Proposed Residential Development

Station Road, Royston

DR/13273/TN01 - 11 September 2015

We refer to the above planning application and the highway consultation response dated 8th September 2015, which is attached as **Appendix 1** for ease of reference. The issues raised within the consultation response have all been addressed and we have used the same item numbering below to provide further information and responses:

Drawing Title
ACCESS PROPOSALS

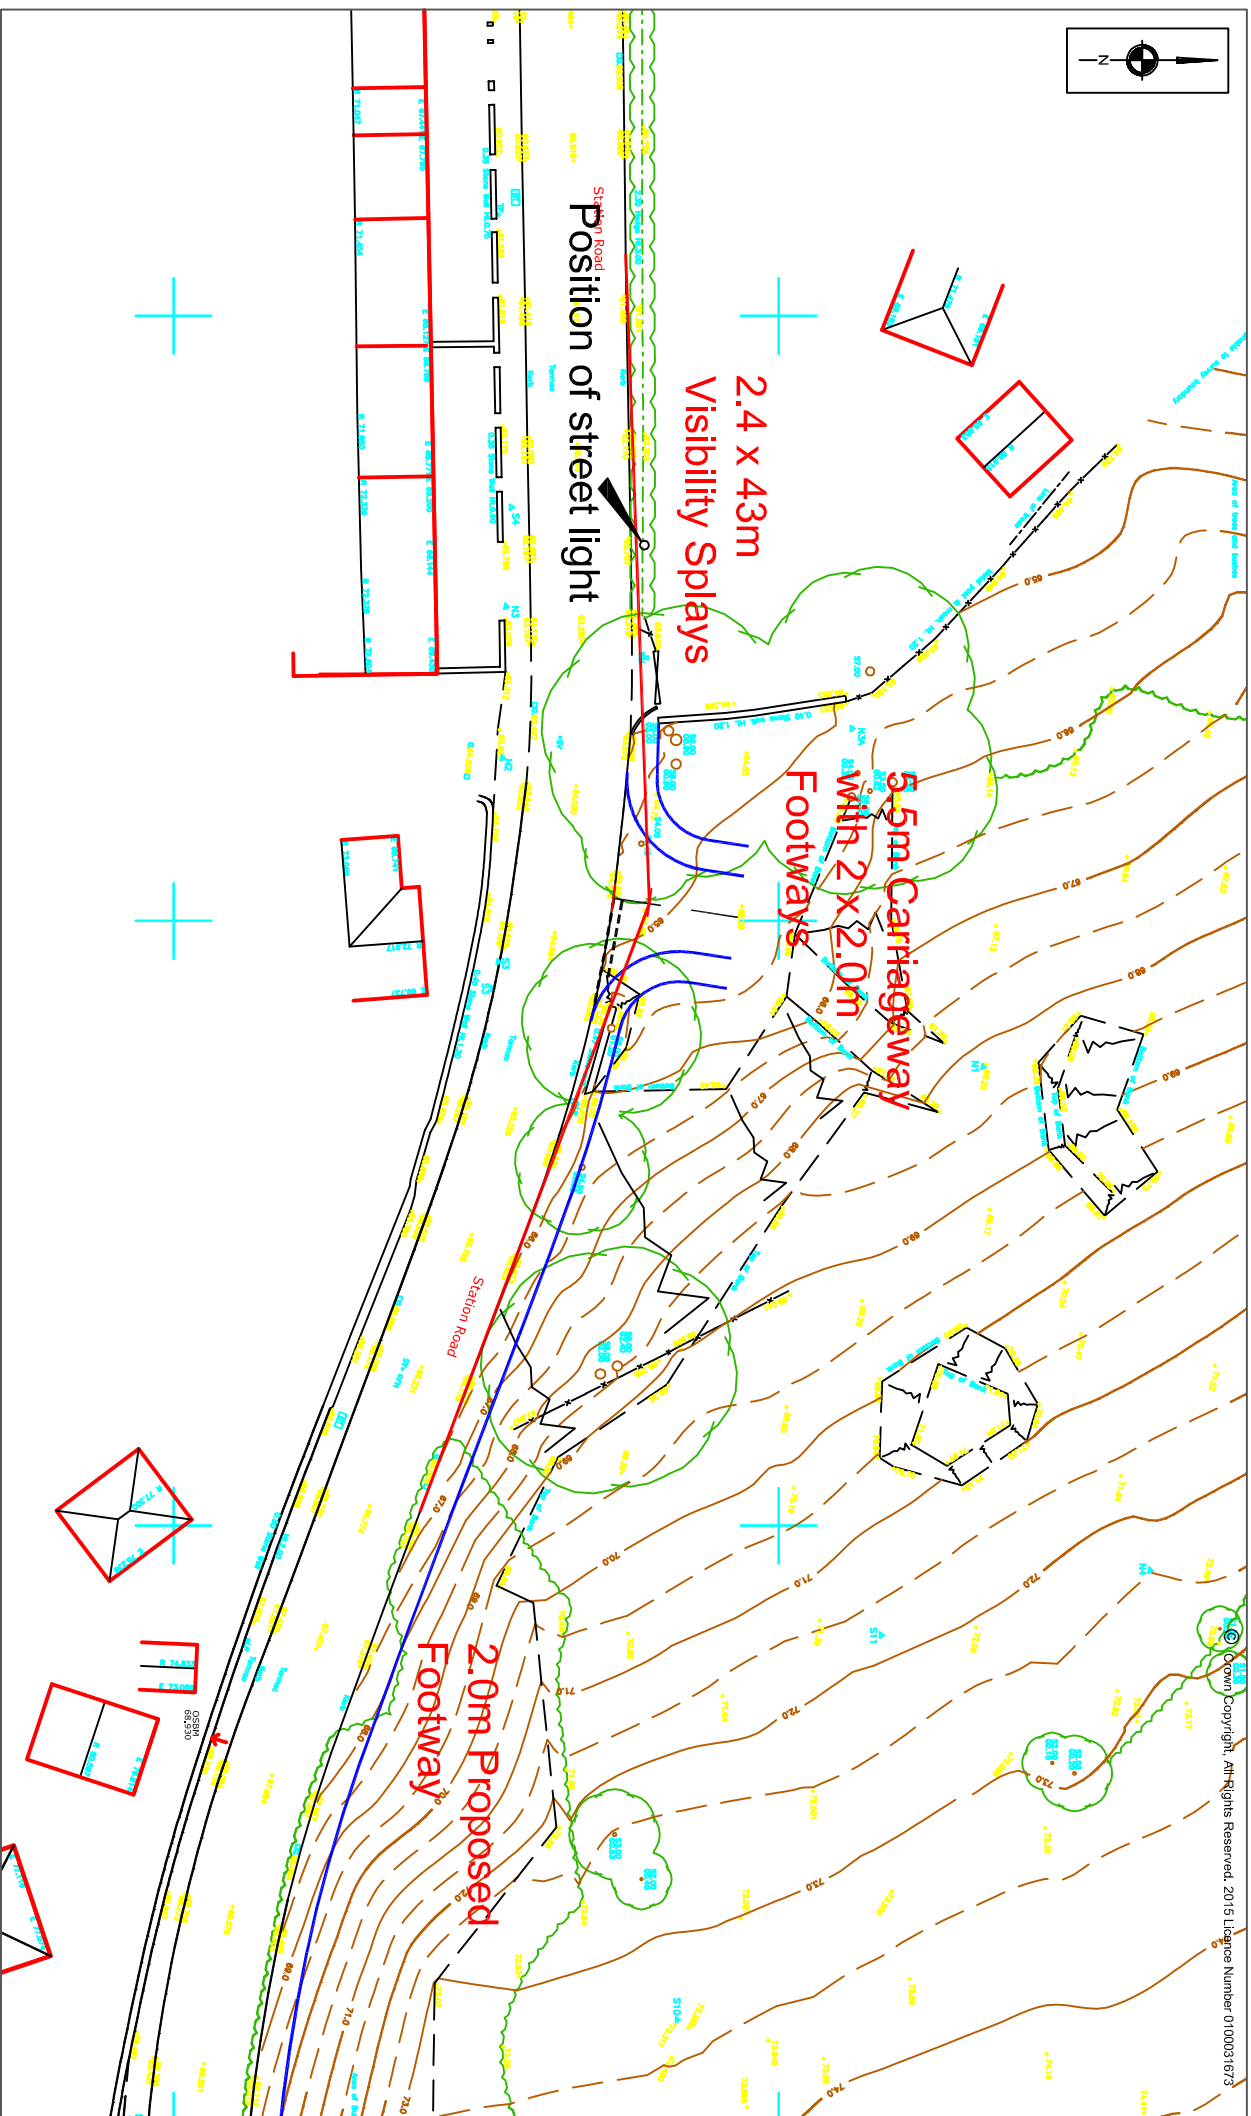
- 2.Visibility splays, having the dimensions 2.4m x 90m, must be safeguarded at the access/egress, such that there is no obstruction to visibility, and forming part of the adopted highway. The plan needs extending to demonstrate that this can be achieved in both directions on the horizontal plane.

- 3.Further details will have to be submitted to demonstrate that 90m can also be achieved in the vertical plane. I am concerned that due to the vertical alignment of the highway, sufficient forward visibility cannot be achieved, which will result in rear end shunts for vehicles waiting to turn right into the site.

2. The request for visibility splays of 2.4 x 90m has been superseded by the introduction of both Manual for Streets and the South Yorkshire Residential Design Guide, which adopts the visibility requirements from Manual for Streets. In the vicinity of the site traffic speeds are mostly below 30mph, due to the horizontal and vertical alignment of the carriageway. For traffic speeds of up to 30mph the design guidance confirms that visibility of 2.4 x 43m is required. These visibility splays have been incorporated into the access layout drawing which is included as **Appendix 2**. A Condition requiring the provision and protection of these visibility splays can be attached to the planning permission if necessary.

3. In the vertical plane it is clear that the 43m visibility can be secured without difficulty. There is a constant gradient in both directions from the access and subject to visibility splays being provided in the horizontal plane, and a restriction on the height of any obstruction within the highway will ensure that the visibility is protected. It should be noted that the full extent of the visibility splays will be contained within the public highway, which is proposed to incorporate a 2.0m footway along the site frontage. The photographs below show the area over which visibility will be provided:

2.4 x 43m
Visibility Splays

Project Title	Drawing Title	Scale	By	Drawing No.
STATION ROAD, ROYSTON	SITE LAYOUT WITH ACCESS ROAD LEVELS	1:500 @ A4	-	SCP/13273/F03
		Date	Checked	
		SEPT 15	-	
		Approved/Unapproved	Status	Revision
		UNAPPROVED	PLANNING	-

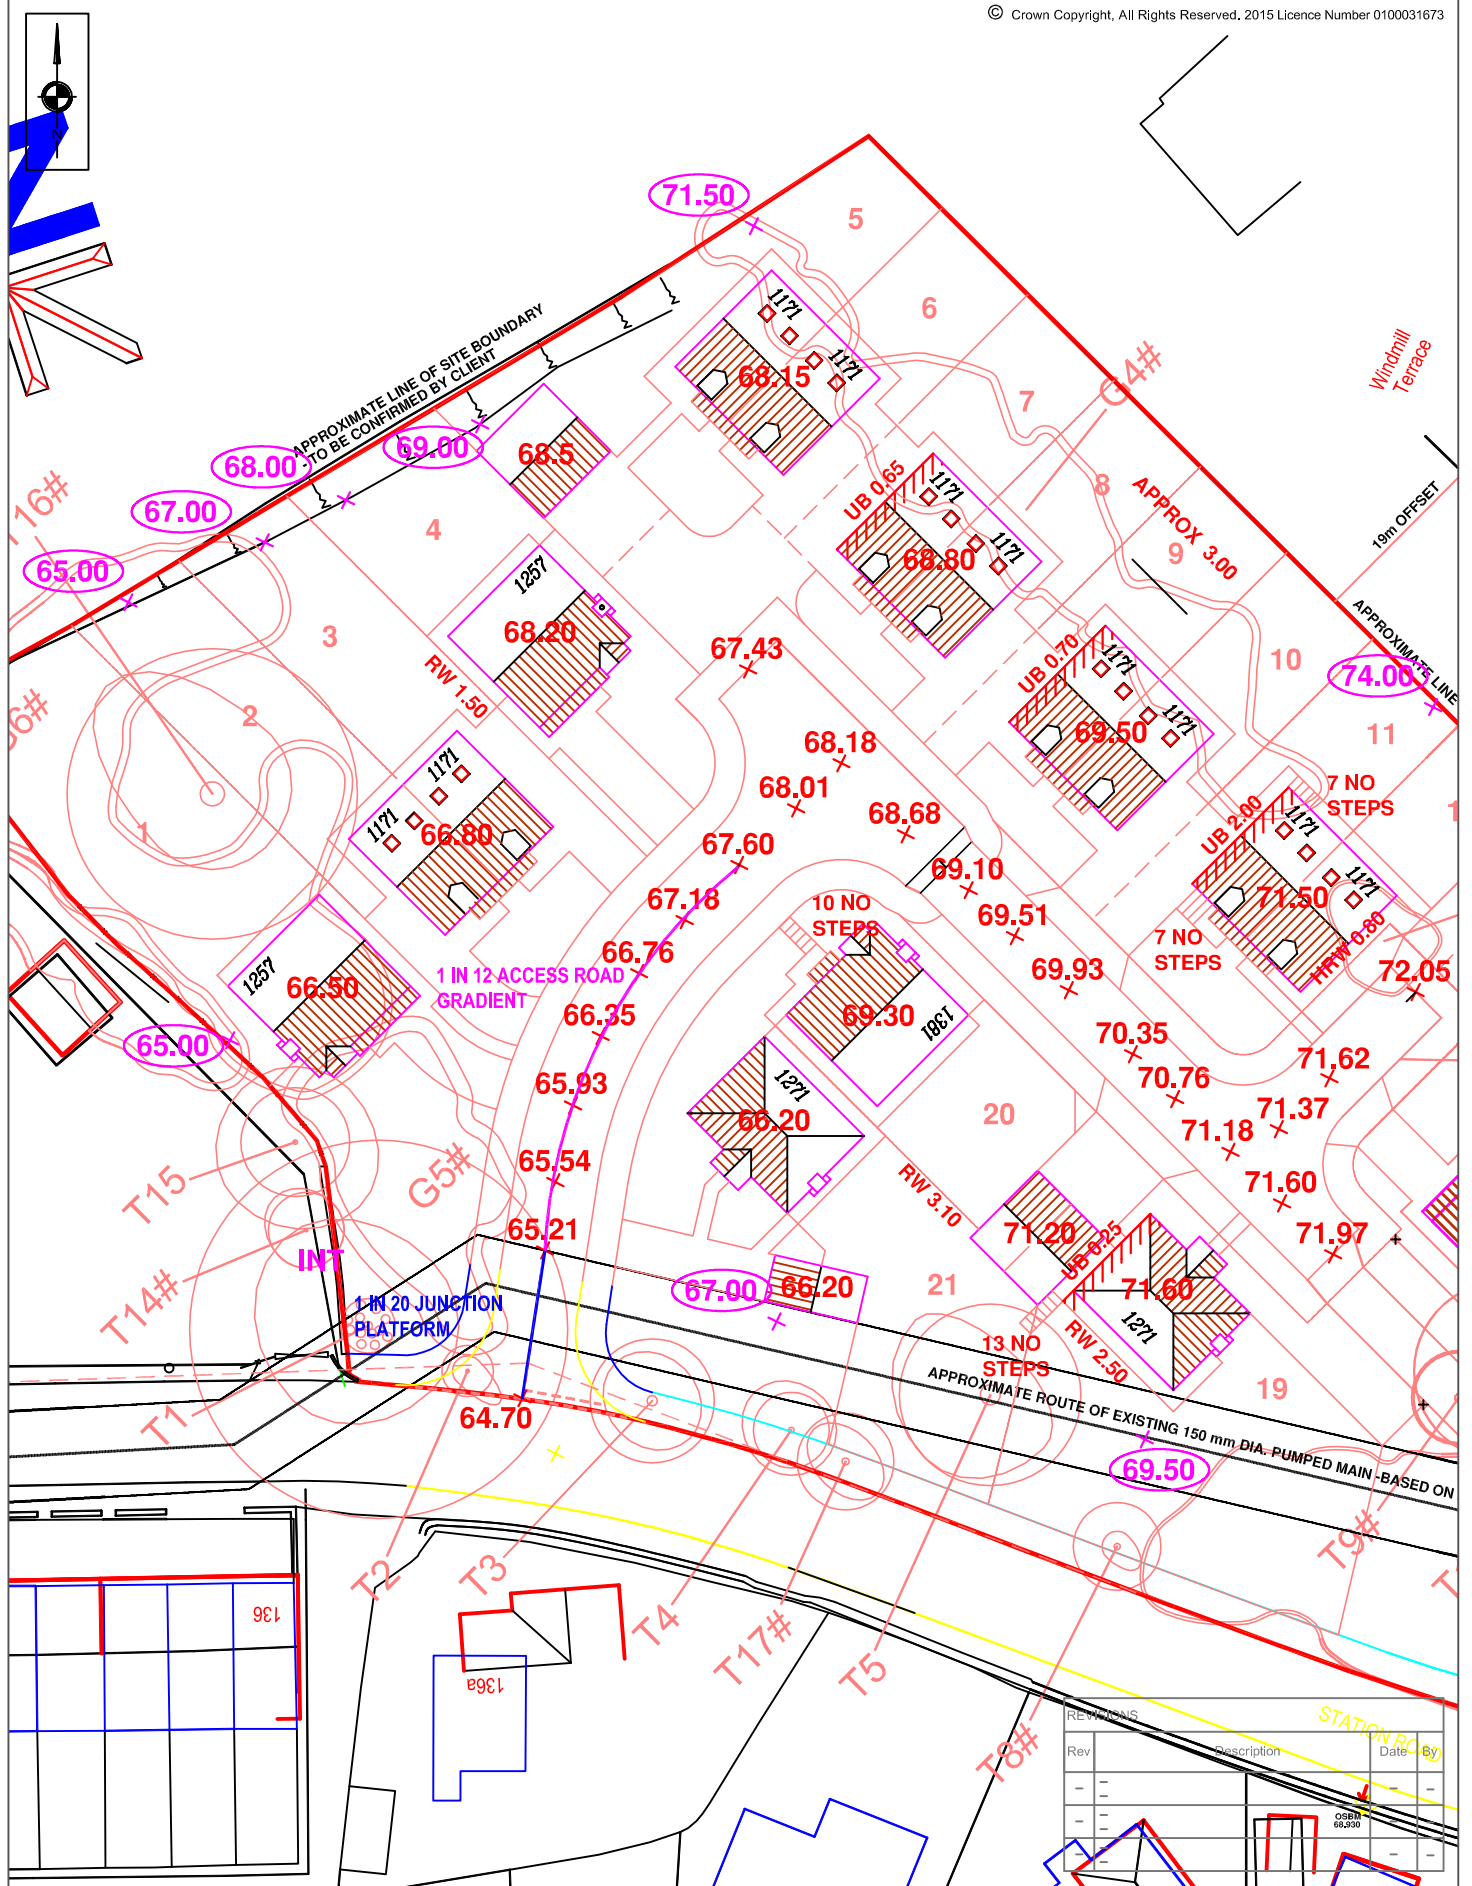
10.At the junction with Station Road, a 5m long platform at 1 in 20 will be required. Gradients thereafter should not exceed 1 in 12.

10. The junction design incorporates a 1 in 20 platform over the first 10m, and over the next 30m the gradient is shown to be 1 in 12.5. The Section 38 Agreement for the roads will ensure that

these adoption standards are achieved. The drawing attached as **Appendix 3** shows the road levels that are proposed.
